S4.55 LIST OF AMENDMENTS:

PROJECT  
THREE STOREY RESIDENTIAL FLAT BUILDING WITH BASEMENT CAR PARK AT:  
5 COMMONWEALTH PDE, MANLY, NSW  
CLIENT  
C.G. & I.B. KOUTSOS

DRAWING TITLE	STATUS	NUMBER	REVISION
GROUND FLOOR PLAN	S4.55	A1.01	s4.55
SCALE	STATUS	NUMBER	REVISION
1:100 @A3	S4.55	A1.01	s4.55

DRAWING TITLE	STATUS	NUMBER	REVISION
LEVEL 2 PLAN	S4.55	A1.03	s4.55
SCALE	1:100 @A3		
PROJECT	CPM

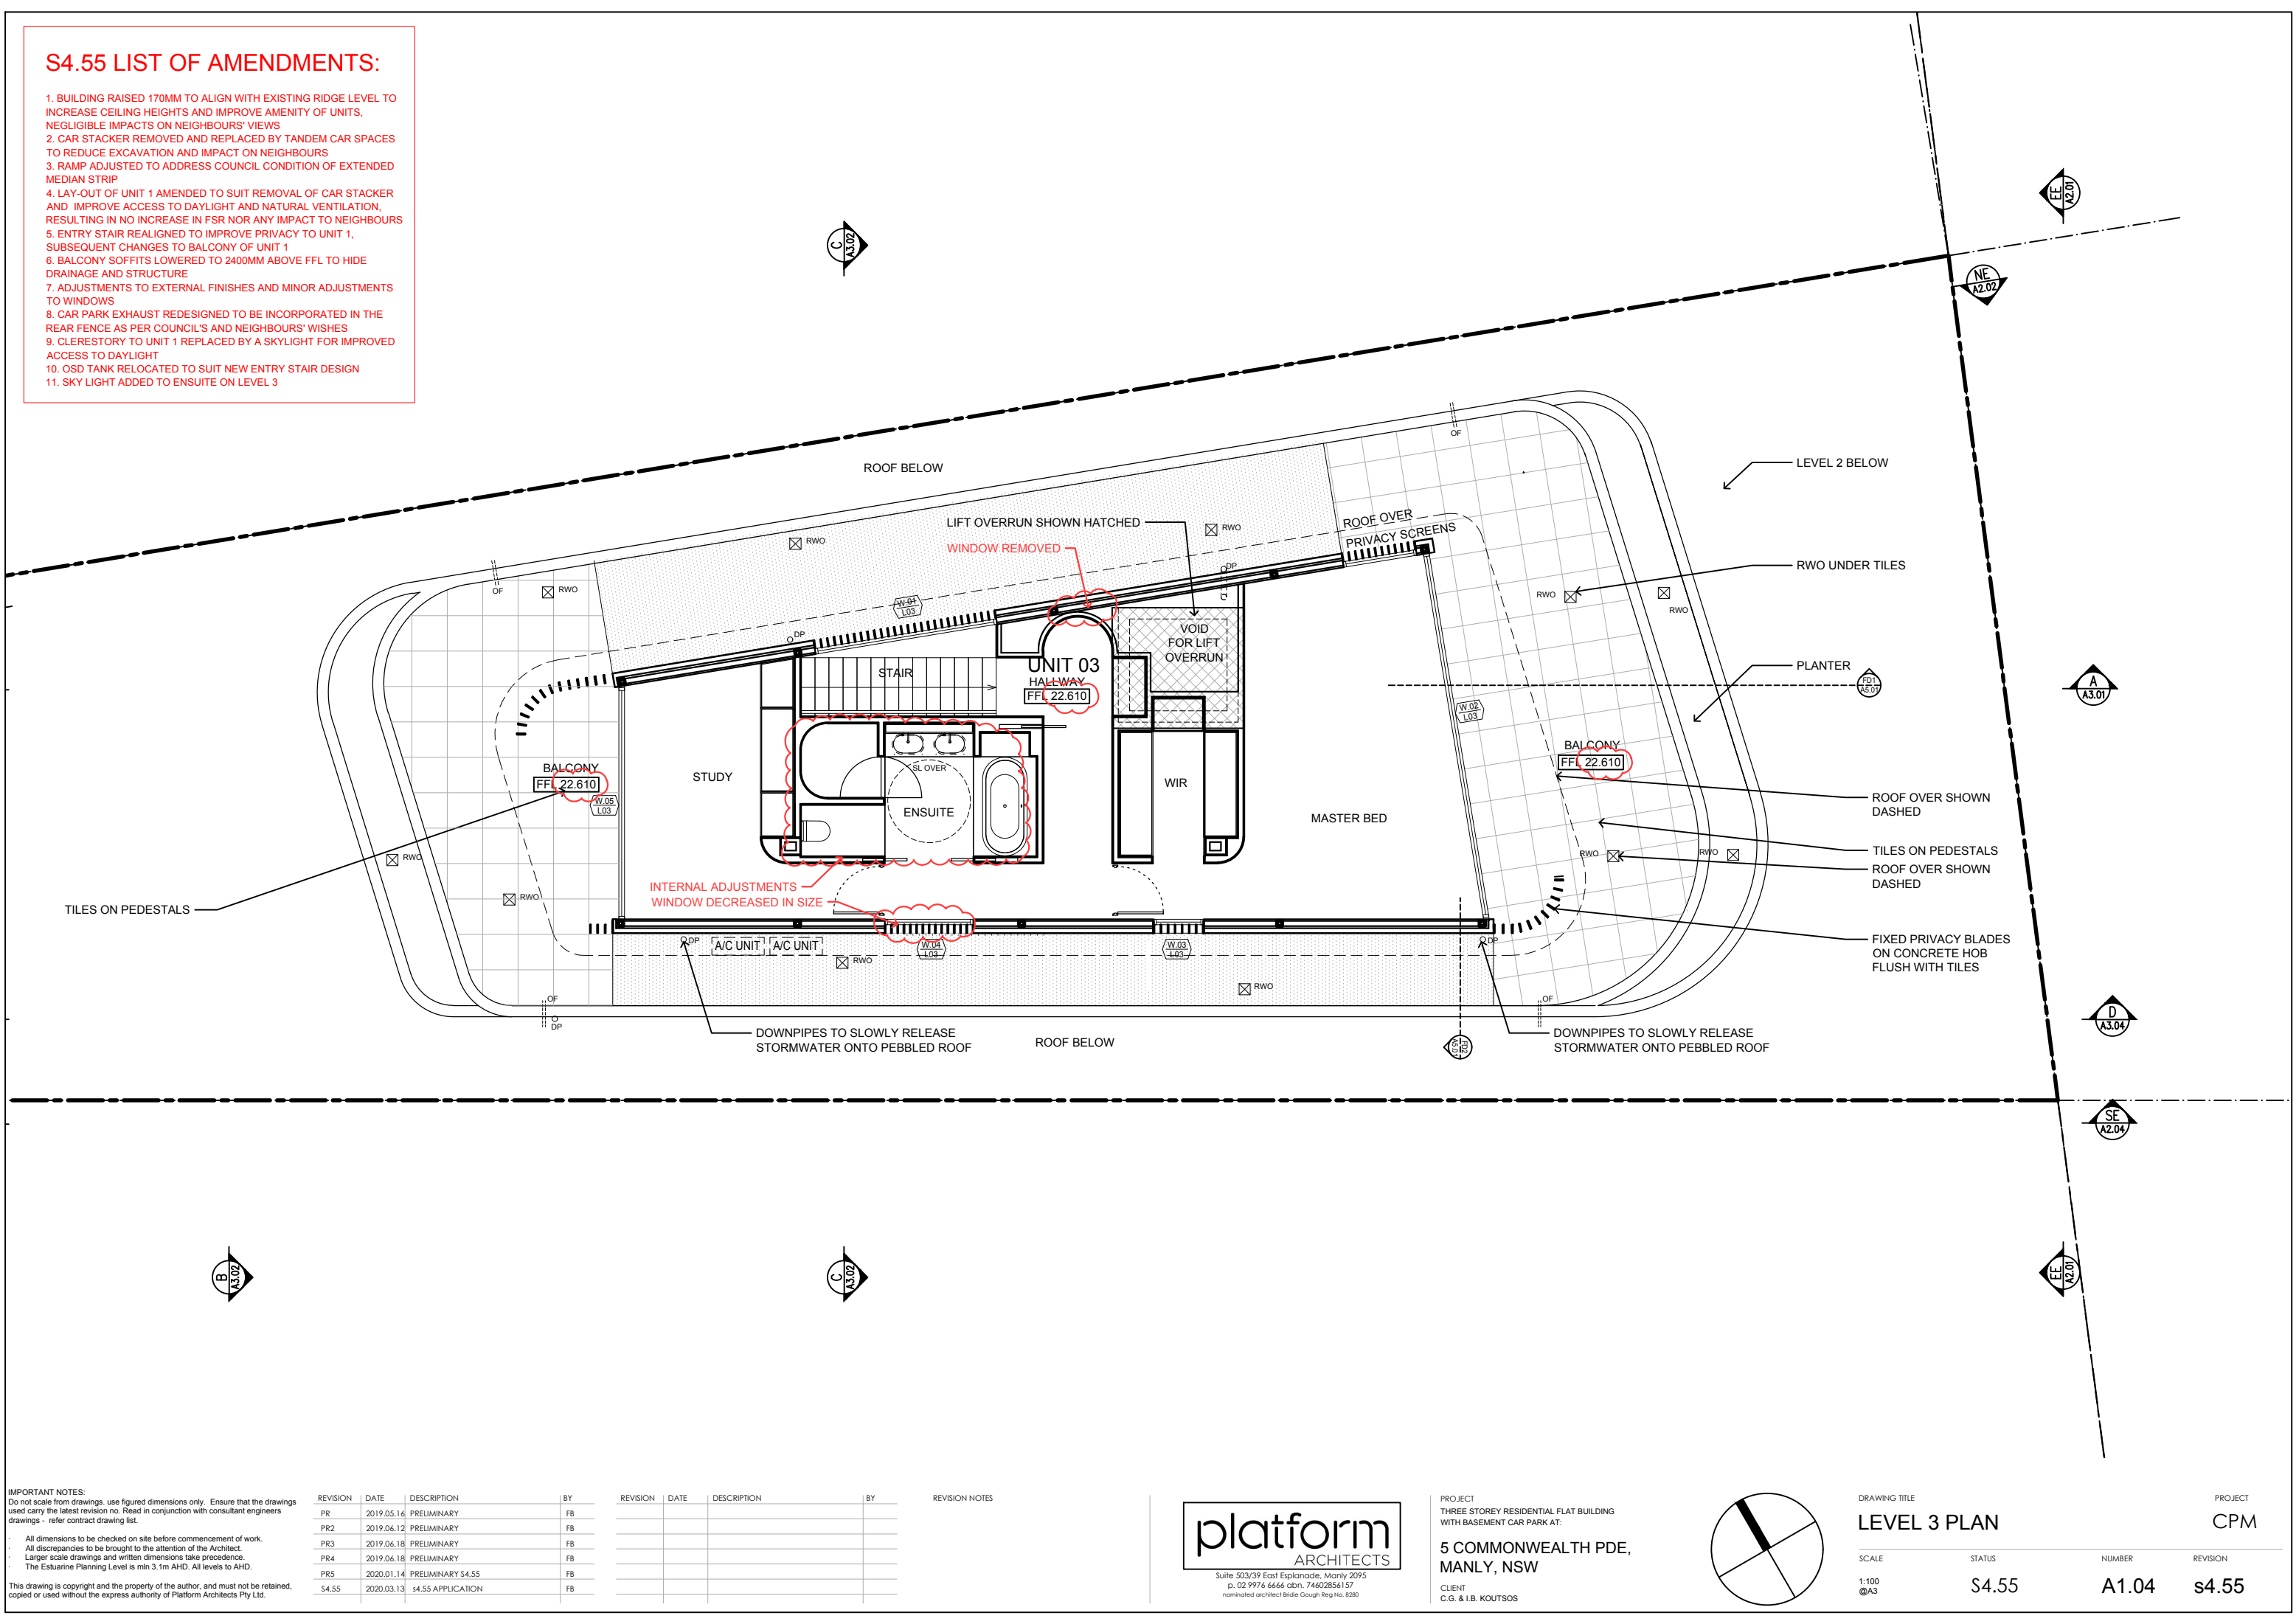
1. BUILDING RAISED 170MM TO ALIGN WITH EXISTING RIDGE LEVEL TO INCREASE CEILING HEIGHTS AND IMPROVE AMENITY OF UNITS, NEGLIGIBLE IMPACTS ON NEIGHBOURS' VIEWS

2. CAR STACKER REMOVED AND REPLACED BY TANDEM CAR SPACES TO REDUCE EXCAVATION AND IMPACT ON NEIGHBOURS
3. RAMP ADJUSTED TO ADDRESS COUNCIL CONDITION OF EXTENDED MEDIAN STRIP

4. LAY-OUT OF UNIT 1 AMENDED TO SUIT REMOVAL OF CAR STACKER AND IMPROVE ACCESS TO DAYLIGHT AND NATURAL VENTILATION, RESULTING IN NO INCREASE IN FSR NOR ANY IMPACT TO NEIGHBOURS

5. ENTRY STAIR REALIGNED TO IMPROVE PRIVACY TO UNIT 1, SUBSEQUENT CHANGES TO BALCONY OF UNIT 1
6. BALCONY SOFFITS LOWERED TO 2400MM ABOVE FFL TO HIDE DRAINAGE AND STRUCTURE

7. ADJUSTMENTS TO EXTERNAL FINISHES AND MINOR ADJUSTMENTS TO WINDOWS
8. CAR PARK EXHAUST REDESIGNED TO BE INCORPORATED IN THE REAR FENCE AS PER COUNCIL'S AND NEIGHBOURS' WISHES

9. CLERESTORY TO UNIT 1 REPLACED BY A SKYLIGHT FOR IMPROVED ACCESS TO DAYLIGHT
10. OSD TANK RELOCATED TO SUIT NEW ENTRY STAIR DESIGN
11. SKY LIGHT ADDED TO ENSUITE ON LEVEL 3

DRAWING TITLE	STATUS	NUMBER	REVISION
LEVEL 3 PLAN	S4.55	A1.04	s4.55
SCALE	1:100 @A3		
PROJECT	CPM

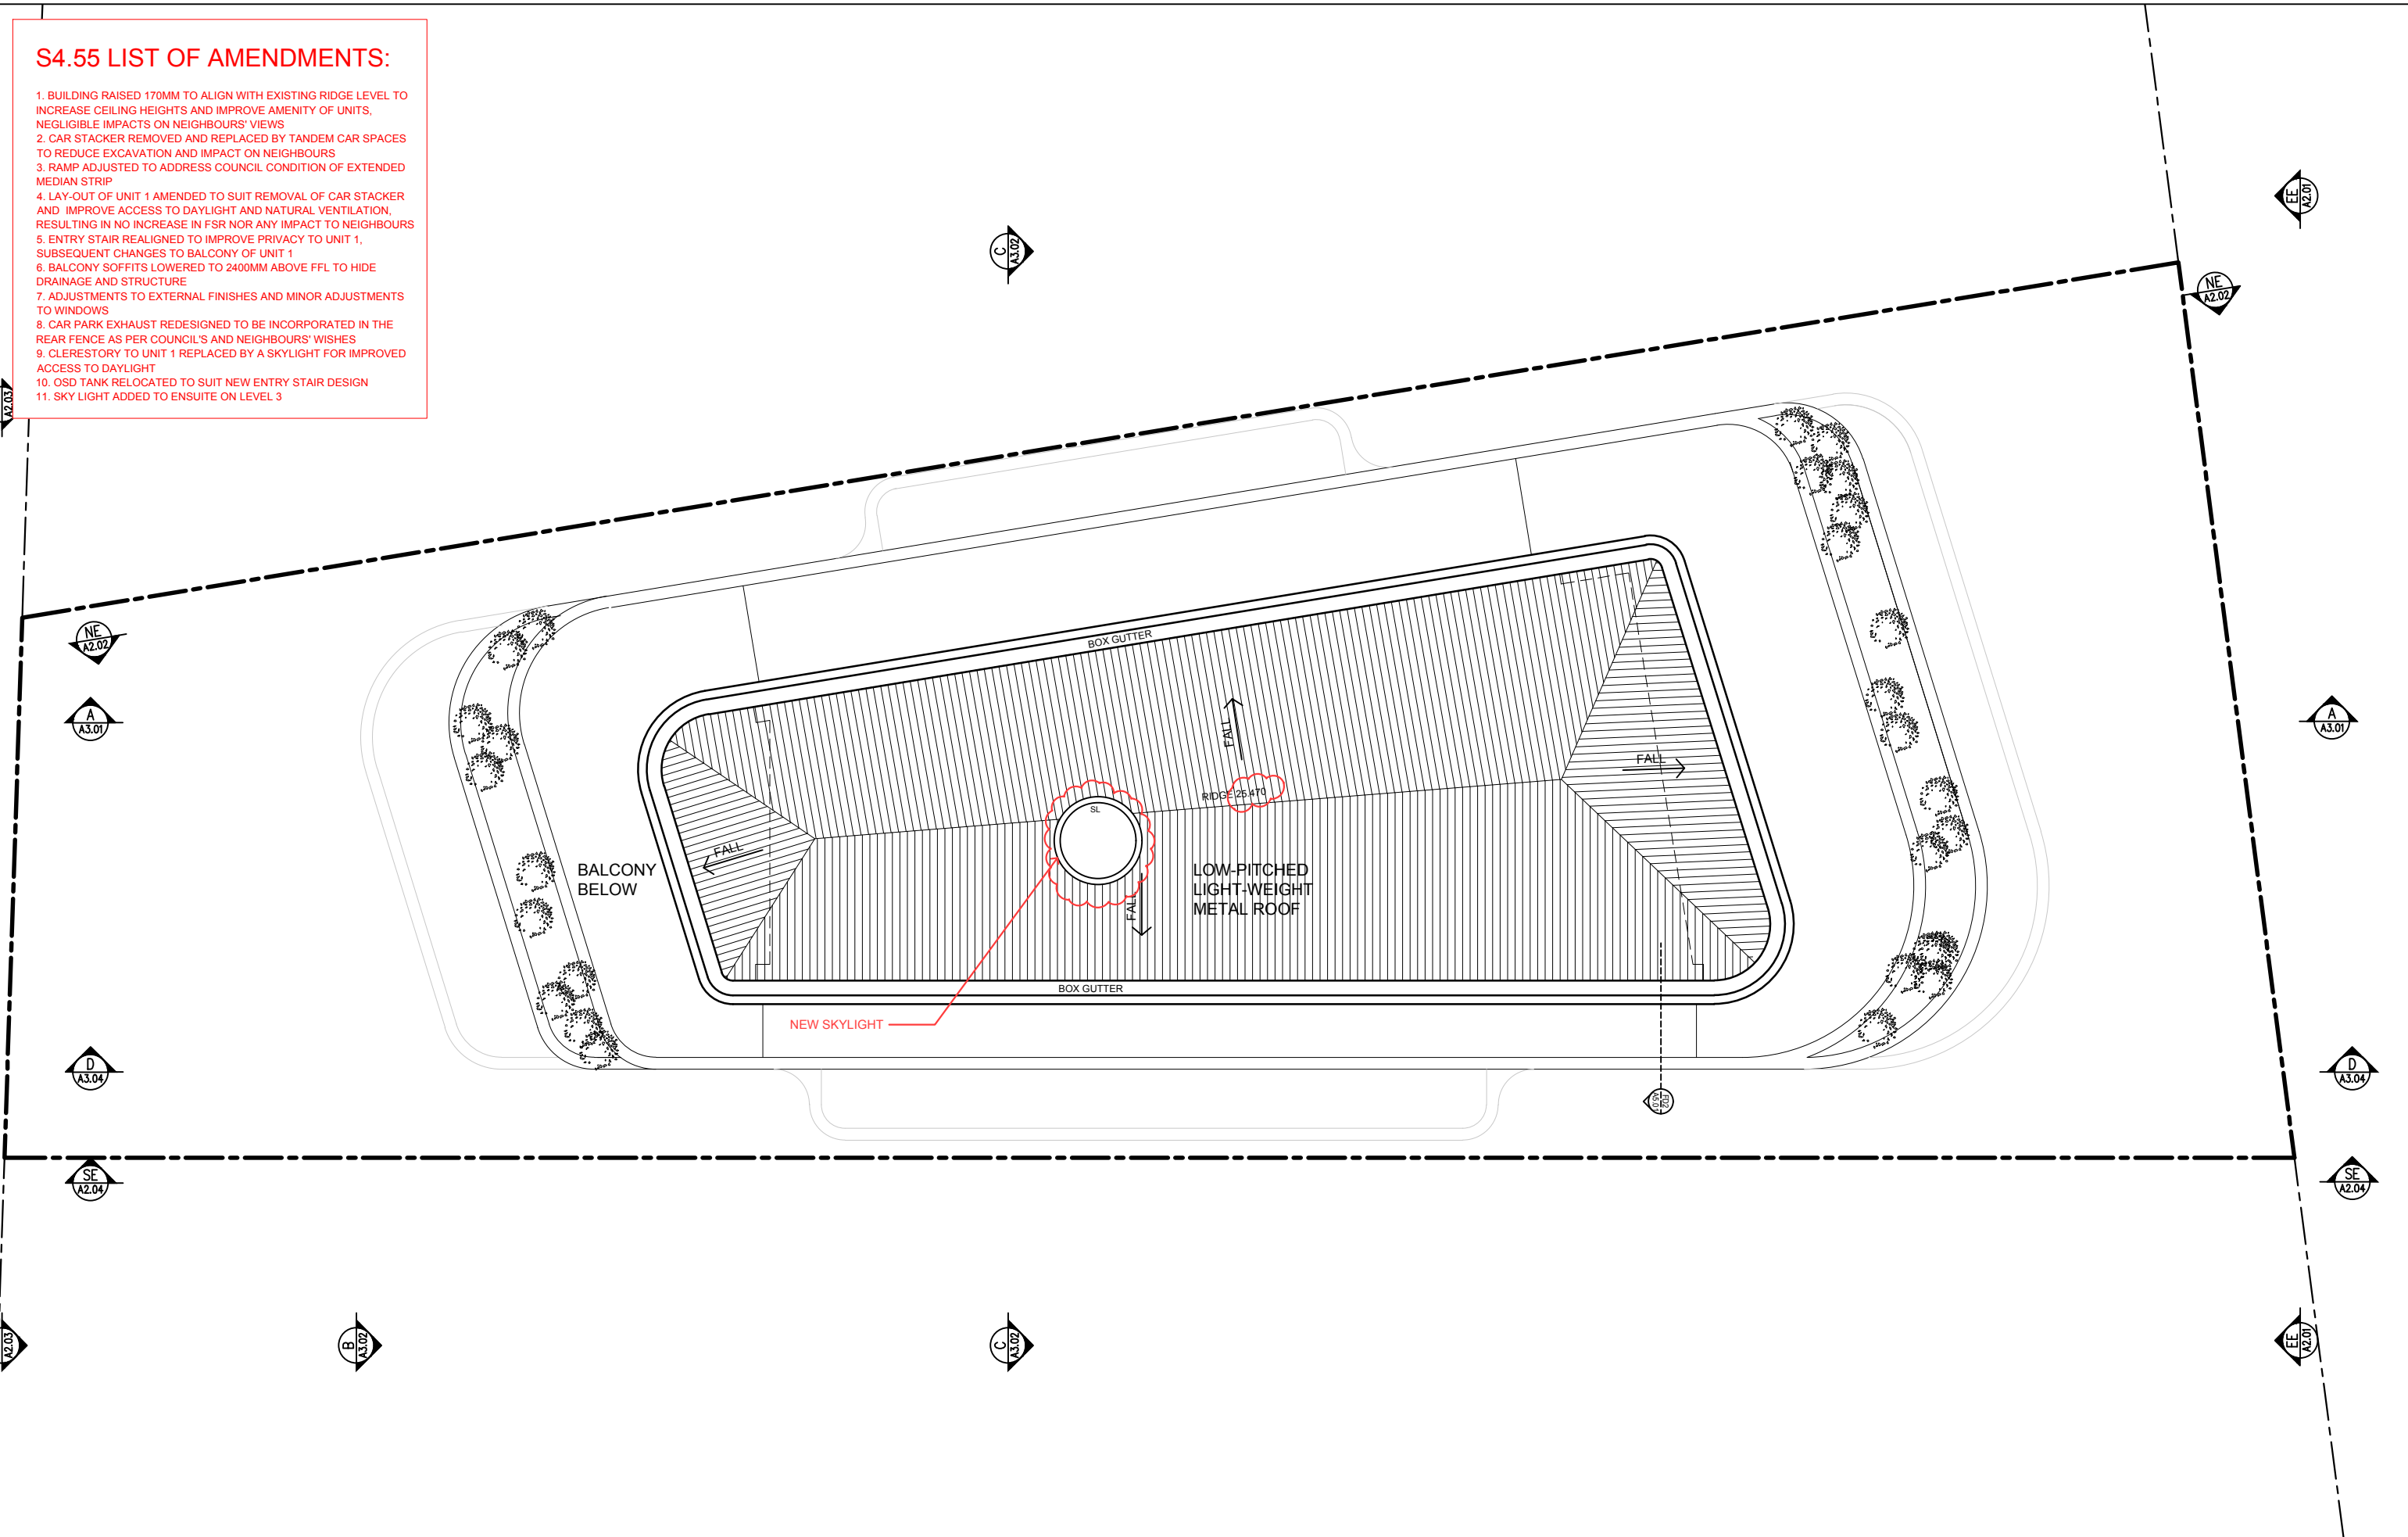
1. BUILDING RAISED 170MM TO ALIGN WITH EXISTING RIDGE LEVEL TO INCREASE CEILING HEIGHTS AND IMPROVE AMENITY OF UNITS, NEGLIGIBLE IMPACTS ON NEIGHBOURS' VIEWS

2. CAR STACKER REMOVED AND REPLACED BY TANDEM CAR SPACES TO REDUCE EXCAVATION AND IMPACT ON NEIGHBOURS
3. RAMP ADJUSTED TO ADDRESS COUNCIL CONDITION OF EXTENDED MEDIAN STRIP

4. LAY-OUT OF UNIT 1 AMENDED TO SUIT REMOVAL OF CAR STACKER AND IMPROVE ACCESS TO DAYLIGHT AND NATURAL VENTILATION, RESULTING IN NO INCREASE IN FSR NOR ANY IMPACT TO NEIGHBOURS

5. ENTRY STAIR REALIGNED TO IMPROVE PRIVACY TO UNIT 1, SUBSEQUENT CHANGES TO BALCONY OF UNIT 1
6. BALCONY SOFFITS LOWERED TO 2400MM ABOVE FFL TO HIDE DRAINAGE AND STRUCTURE

7. ADJUSTMENTS TO EXTERNAL FINISHES AND MINOR ADJUSTMENTS TO WINDOWS
8. CAR PARK EXHAUST REDESIGNED TO BE INCORPORATED IN THE REAR FENCE AS PER COUNCIL'S AND NEIGHBOURS' WISHES

9. CLERESTORY TO UNIT 1 REPLACED BY A SKYLIGHT FOR IMPROVED ACCESS TO DAYLIGHT
10. OSD TANK RELOCATED TO SUIT NEW ENTRY STAIR DESIGN
11. SKY LIGHT ADDED TO ENSUITE ON LEVEL 3
